Approved by  
Ramsey Planning Department  
Date: 7/30/13 - TB  
Comments: CONTINGENT ON  
PVD APPROVAL FINDINGS

**EXTERIOR ELEVATIONS**  
DRAWN BY: SAR  
SCALE: AS NOTED  
DATE: 6/3/13

**PROJECT NAME & ADDRESS**  
SPEC  
7339 148TH LN  
RAMSEY, MN. 55303  
LOT # 10 BLOCK #3  
TOWN CENTER GARDENS 3RD ADD

**PLAN NUMBER**  
035-13

**RIGHT ELEVATION**  
SCALE: 1/8" = 1'-0"

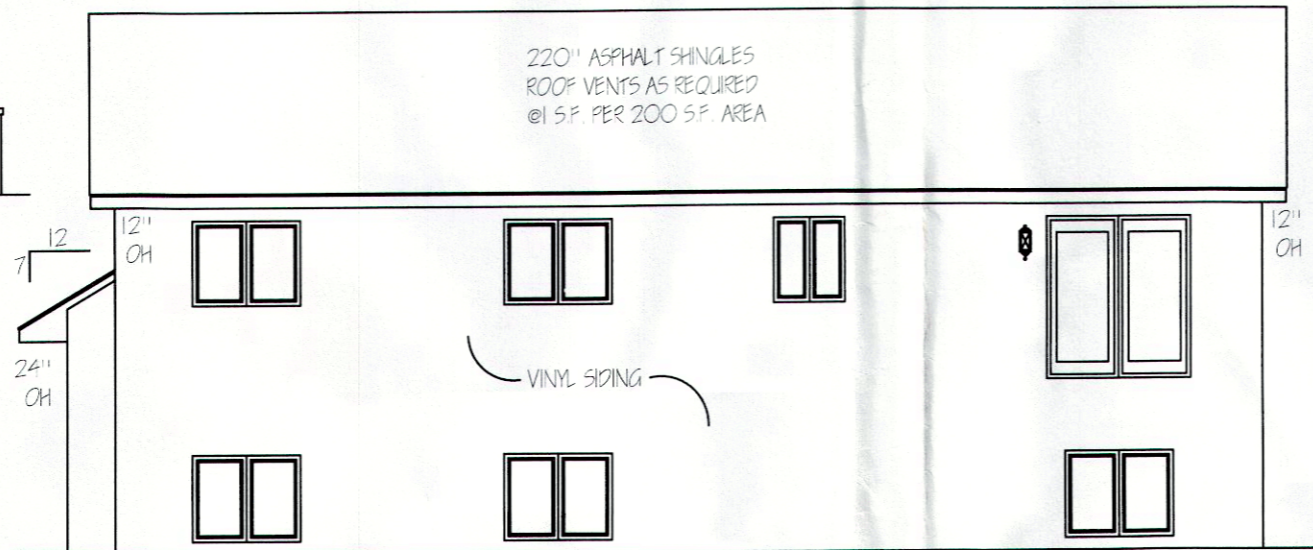
NO OCCUPANCY CERTIFICATE  
PRIOR TO WATER METER AND  
REMOTE INSTALLATION

NO OCCUPANCY CERTIFICATE  
BEFORE FINAL ELECTRICAL INSPECTION

**REAR ELEVATION**  
SCALE: 1/8" = 1'-0"

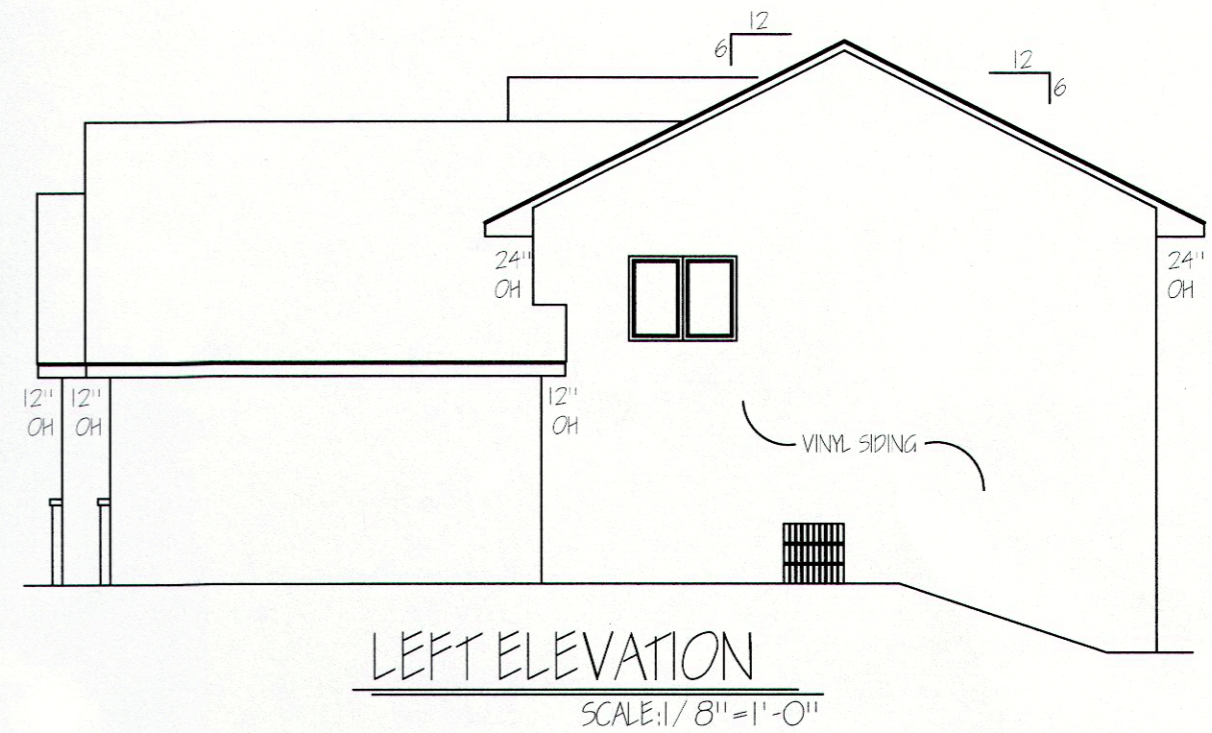
EGRESS WINDOWS REQUIRED  
IN EACH BEDROOM AND BASEMENT

**FRONT ELEVATION**  
1260 SQ. FT. SCALE: 1/4" = 1'-0"

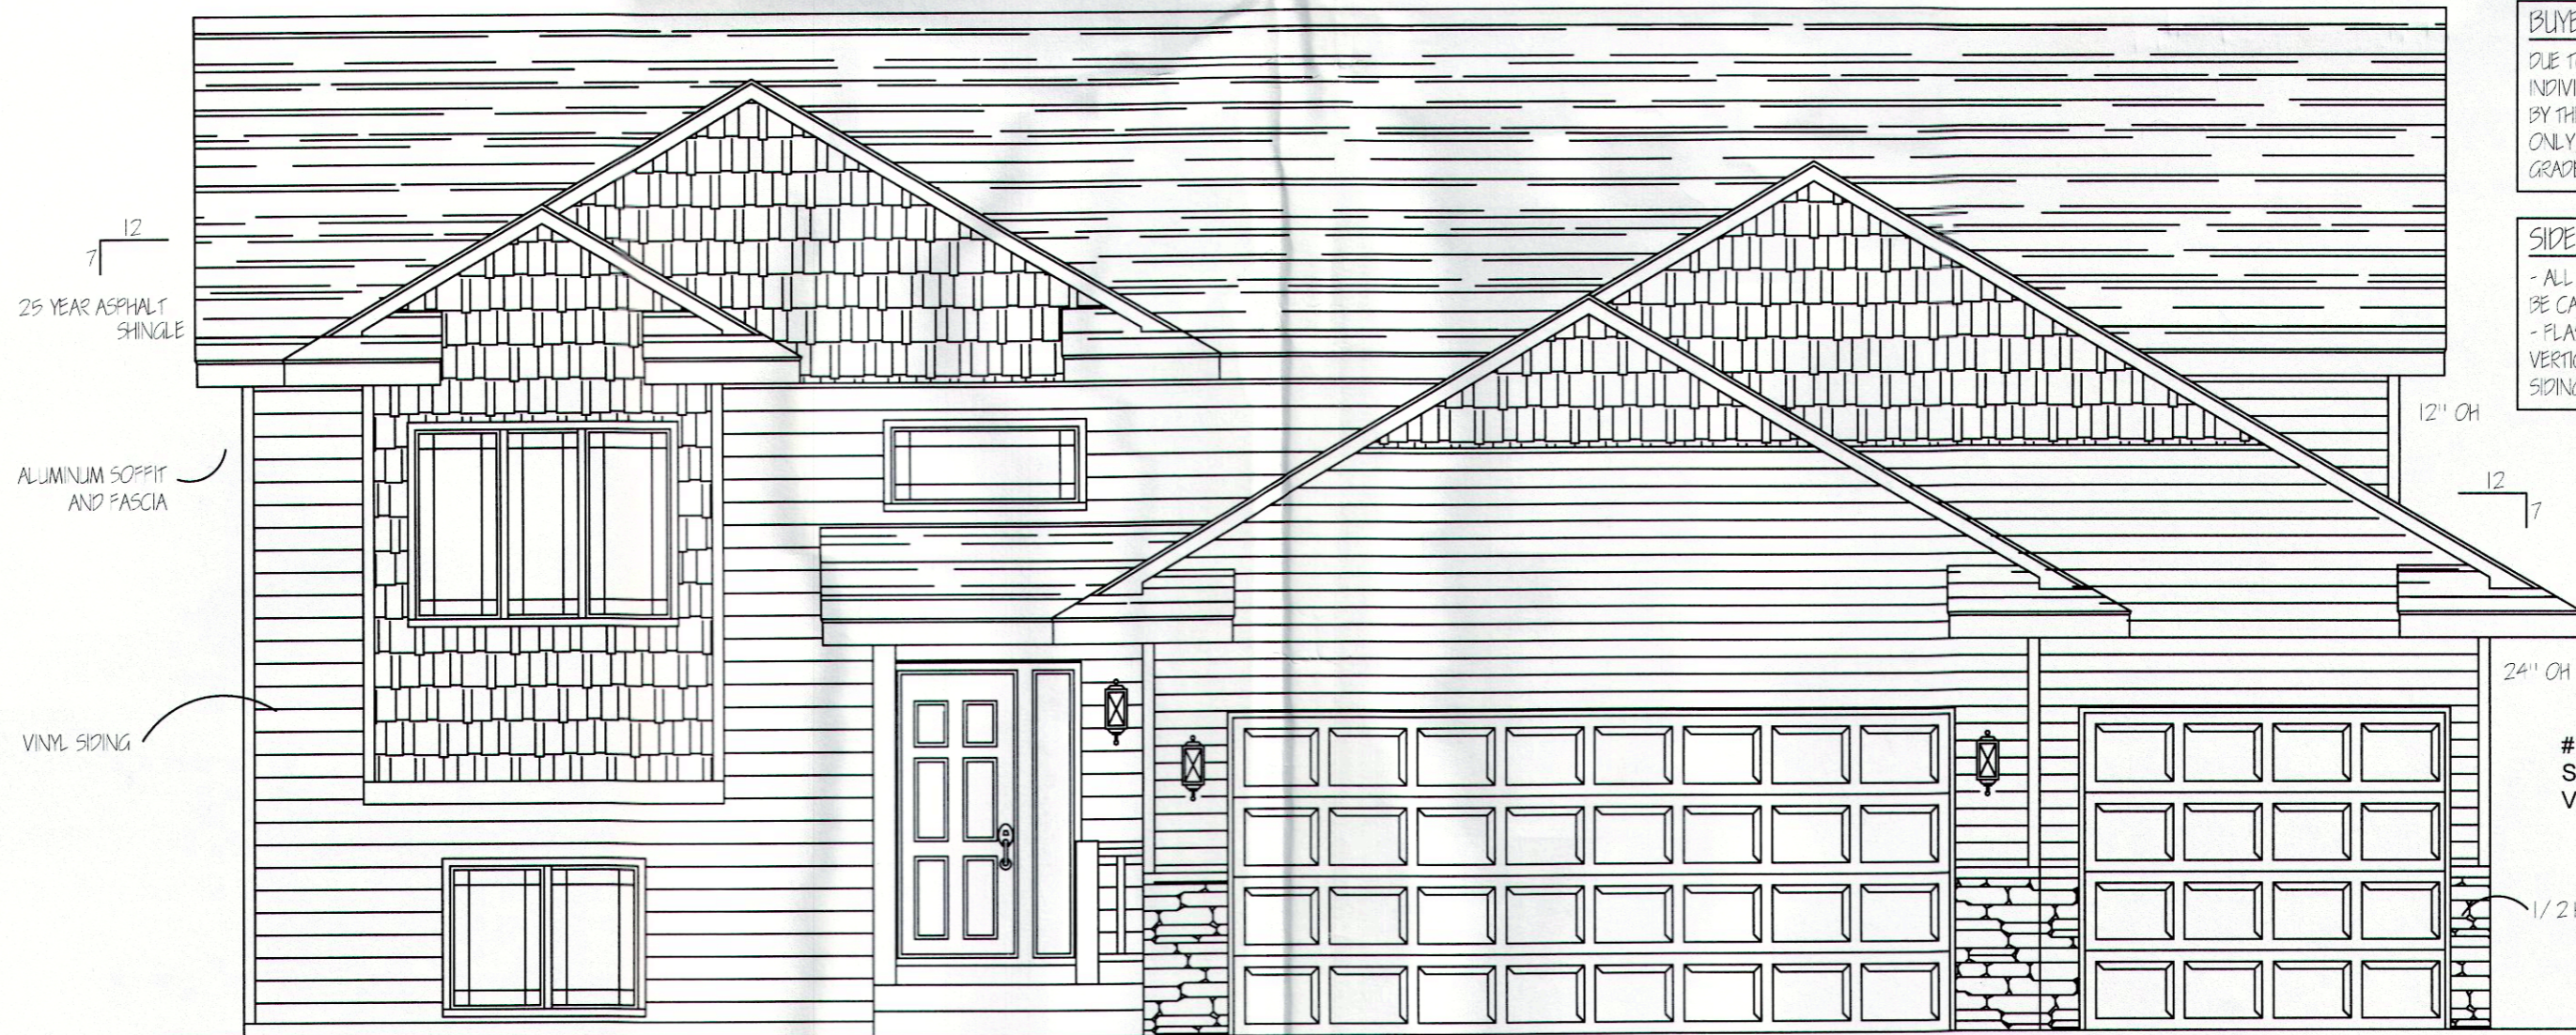
HOUSE NUMBERS REQUIRED  
DO NOT INSTALL ON GARAGE DOOR
